## ADDENDUM No. 2

PROJECT: 20241201 - SB000B - MULTI-BUILDING - Campus Pavement Maintenance (Parkside, CRHC, Northside, SAC, IUPD)  
CLIENT: Indiana University South Bend  
ISSUE DATE: April 23, 2025

INDIANA UNIVERSITY  
CAPITAL PROJECTS  
CONSTRUCTION FENCING SCREEN  
STYLE GUIDE 01/03/2024

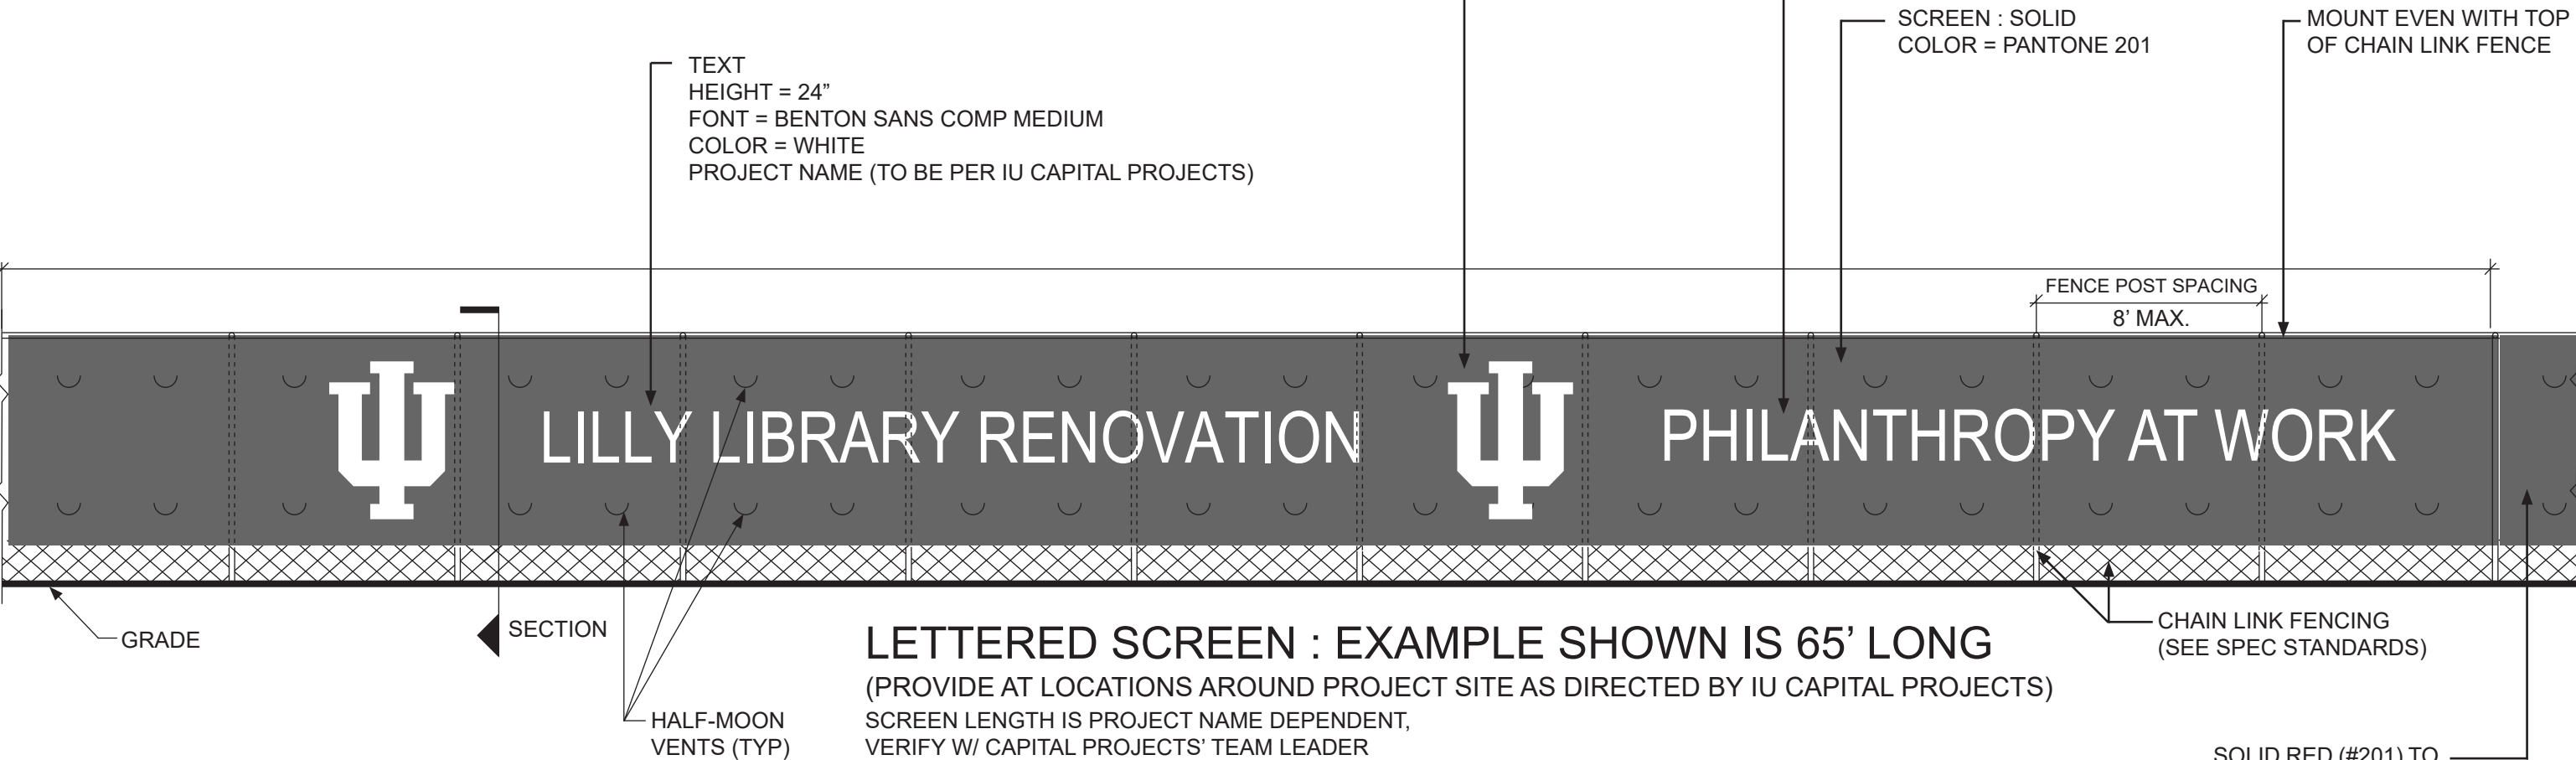
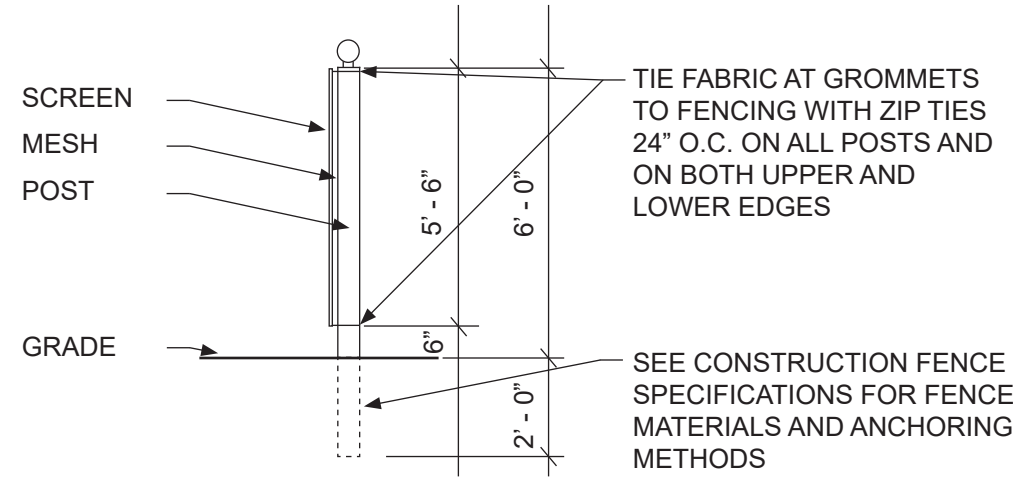
1. Construction Fence detail was unintentionally omitted from the plans and specs and is included in this addendum.
2. An item for removal and replacement of existing curb and gutter at the direction of the IUSB staff or engineer in the field has been added to the list for unit price items on the bid form. It is anticipated that this is the straight curb per the detail on the plans.

1. Construction fence detail is attached.
2. Updated Bid Form is attached for use with updated unit pricing.
